Southern California Edison
WODUP A.13-10-020

DATA REQUEST SET A.13-10-020 WODUP ED-SCE-10

West of Devers Upgrade Project
DATA REQUEST #10

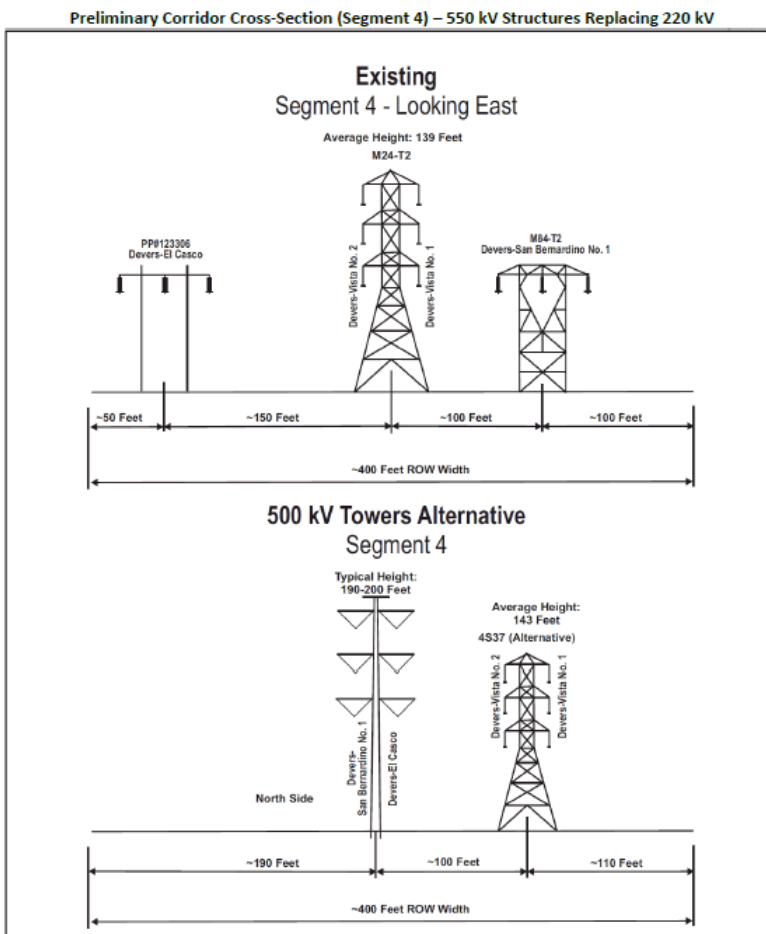
Given the general description of the configuration of 220 kV and 500 kV structures shown in the figure on the following page, please answer the following questions:

(A) Please review the preliminary cross-section (presented below), and comment on the assumptions on tower heights and separation of structures.

In general, the assumptions on tower heights and separation of structures as represented in the cross section for this specific segment of the WOD corridor appear appropriate. However, absent further detail regarding the scope of the proposal for the 500 kV alternative shown, SCE is not able to describe all the potential impacts, concerns and potential feasibility issues of such assumptions and ultimate design.

For example, based on the cross section, SCE could assume that the CPUC is proposing to use 500 kV double circuit TSP structures for the Devers-San Bernardino and Devers-El Casco 220 kV lines across the entire 48-mile WOD corridor or a large portion thereof. Under this scenario, SCE would have multiple concerns and feasibility issues that would need to be assessed. For instance, installing 500 kV structures across Segment 5 would be legally infeasible as SCE does not have the necessary property rights to install 500 kV structures across the Morongo Reservation. Based on several previous responses to CPUC data requests by SCE and Morongo as well as briefings and meetings SCE and Morongo have conducted with the Energy Division, SCE believes that the CPUC understands this constraint related to what SCE is allowed to construct across the Morongo Reservation as part of the Proposed Project. However, and again under this scenario, if 500 kV structures are also proposed in Segments 4 and 6 that border the Morongo Reservation, those structures may never be able to operate at 500 kV, as routing a 500 kV line through the Morongo Reservation may not be feasible. If a future need for a 500 kV line materializes at some point, and SCE is not able to obtain an agreement with the Morongo regarding routing such a line across the Reservation, then SCE would have to explore other options similar to the system alternatives included in SCE's PEA. These other options may not allow SCE to use any of the 500 kV structures. Additionally, if SCE were successful in obtaining a future agreement with the Morongo on the routing of a future 500 kV line across the Reservation, the location of that routing may be significantly different than the locations of the proposed 220 kV structures that would traverse the Reservation as part of the Proposed Project. Significant changes in the location of routing a potential future 500 kV line across the Reservation could impair SCE's ability to align that routing with the predetermined placement of 500 kV structures that border Segments 4 and 6 requiring SCE to either move those structures or to leave them in place and only operate the line at 220 kV.

Moreover, SCE could also assume that the use of 500 kV structures in Segment 4 and any other segment would preclude the use of other sized transmission lines, should the need develop to site and build additional transmission lines through the WOD corridor. As explained in SCE's response to Data Request Set # 7, Question No. ALT-15.A, it is unknown at this time whether the remaining portion of the ROW would be configured as a single-circuit or double-circuit transmission line, or even what voltage those additional facilities would ultimately be should the need arise for additional transmission capacity beyond the Proposed Project. Additionally, and assuming the 500 kV structures are proposed to operate at 500 kV at some future point in time, the use of 500 kV lines would require the conversion of existing 220 kV substations to contain 500 kV capability or the construction of a new substation that contains 500 kV capability. Limiting SCE's ability to site and build additional transmission lines to only 500 kV in predetermined locations for a need that may not occur for many years runs counter to prudent

Without further detail regarding the scope for this 500 kV alternative, it does not seem to be a practical modification because it could be infeasible, may never be allowed to operate at 500 kV, and would limit SCE's ability to site and build additional transmission lines to voltages that could best serve the future need.

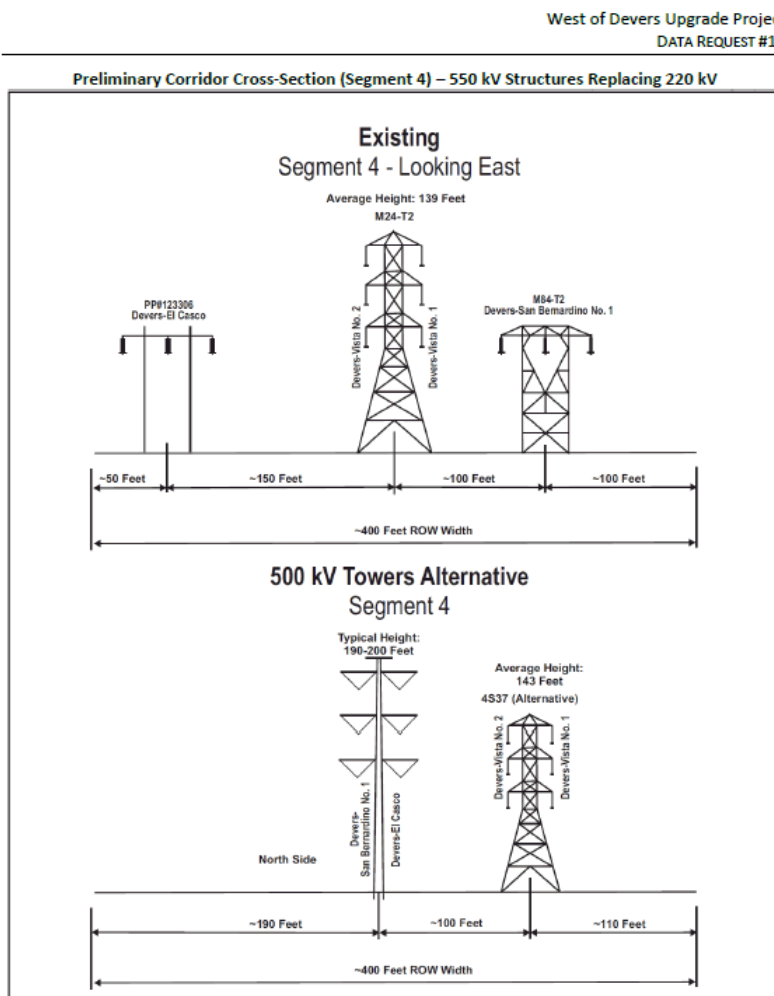
Given the general description of the configuration of 220 kV and 500 kV structures shown in the figure on the following page, please answer the following questions:

(B) For 500 kV TSPs to be installed in this corridor, and assuming the structure separation defined in (A) above between the 500 kV line and the new 220 kV structures, what would be the average span length?

Tower spotting/placement is dependent upon ground topology, assessment of required clearances above various obstacles, as well as associated wire swing analysis (i.e., blowout) to the adjacent transmission lines. Assuming a similar 500 kV and 220 KV structure alignment through the entire 48 mile WOD corridor (not including the portion of the project that traverses the Morongo Reservation), SCE would need to perform a preliminary design effort for each structure in order to provide an average span length as requested in the question. However, assuming the question is limited to only the flatter portions of Segment 4 (e.g., between Highland Springs Road and Interstate 10), then it would be reasonable to expect that the span lengths for the 500 kV structures would be very similar to the span lengths currently designed for the 220 kV structures.

As explained in SCE's response to Question No. ALT-20a, without further detail regarding the scope for this 500 kV alternative, SCE does not believe the use of 500 kV structures to be a practical modification because it could be infeasible, may never be allowed to operate at 500 kV and would limit SCE's ability to site and build additional transmission lines, should a future need arise, to voltages that could best serve that future need.

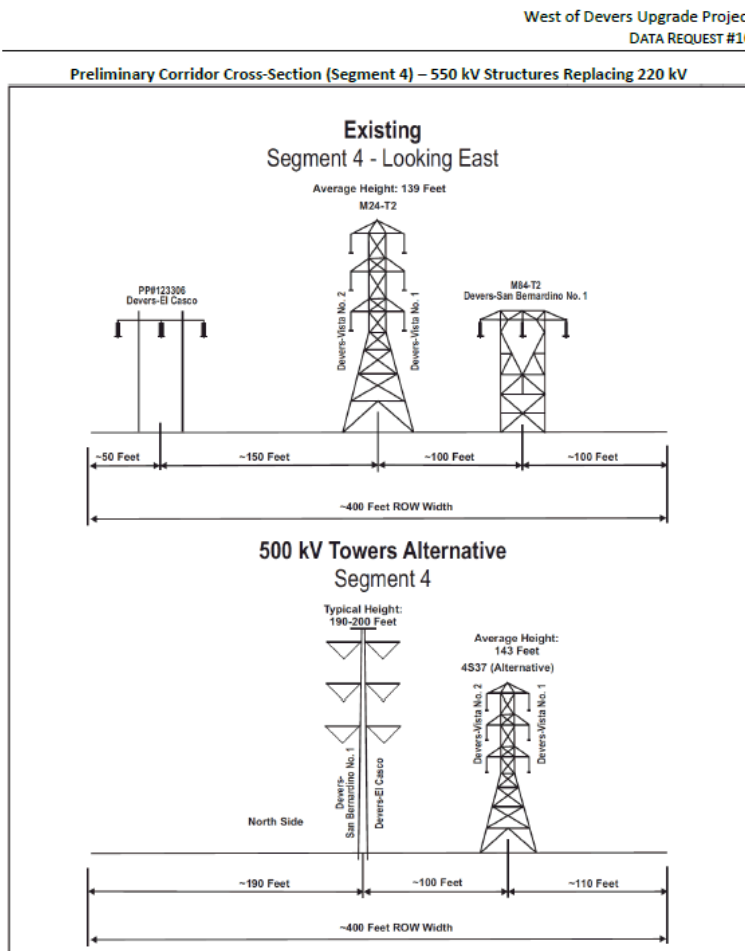
Given the general description of the configuration of 220 kV and 500 kV structures shown in the figure on the following page, please answer the following questions:

(C) Please explain how 500 kV towers could be installed in Segment 2 between San Bernardino Junction and the Vista Substation. Would these towers most likely be installed in SCE's southern separate corridor (currently unaffected by WOD-UP), requiring relocation of the existing 115 kV line currently unaffected by the project?

The use of 500 kV structures in Segment 2 assumes that 500 kV line(s) would need to traverse west of the San Bernardino Junction to Vista Substation, which is not part of SCE's Proposed Project, nor is it known to be a foreseeable future need. As such, SCE has not evaluated any concepts for placing additional transmission lines, regardless of voltage, through Segment 2. Currently, the existing rights-of-way through Segment 2 are not wide enough to place multiple lines adjacent to each other for the full length of this Segment. Any future project that would need to traverse through Segment 2, regardless of voltage level, would likely require the acquisition of new rights. When, or if, that time comes, that future project design team may come to a conclusion that relocation of one or more of the existing transmission lines in that segment may best facilitate the overall process, but that evaluation has not been considered at this time. Additionally, a 500 kV transmission line to Vista Substation would require Vista Substation be converted to contain a 500 kV switchyard. SCE does not have any current expectation that Vista Substation would ever be converted to contain a 500 kV switchyard.

As explained in SCE's response to Question No. ALT-20a, without further detail regarding the scope for this 500 kV alternative, SCE does not believe the use of 500 kV structures to be a practical modification because it could be infeasible, may never be allowed to operate at 500 kV and would limit SCE's ability to site and build additional transmission lines, should a future need arise, to voltages that could best serve that future need.

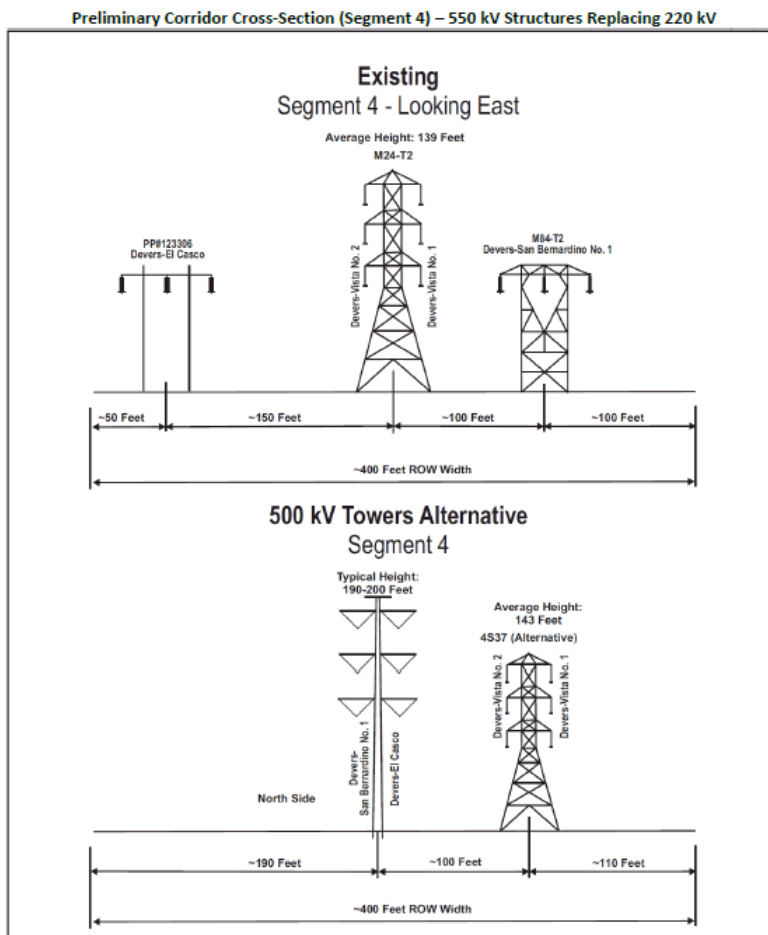
Given the general description of the configuration of 220 kV and 500 kV structures shown in the figure on the following page, please answer the following questions:

(E) Please describe any other specific feasibility concerns about this design.

As described in SCE's response to Question No. ALT-20a, without further detail regarding the scope for this 500 kV alternative, SCE is not able to describe all the potential impacts, concerns and potential feasibility issues of such assumptions and ultimate design. The most availing concerns regarding what is known about this 500 kV alternative is that this alternative may not be feasible, SCE may never be able to operate these structures at 500 kV, and should the need arise for additional capacity in the WOD corridor beyond the Proposed Project, this alternative may limit SCE's ability to site and build additional transmission lines to voltages that could best serve that future need.
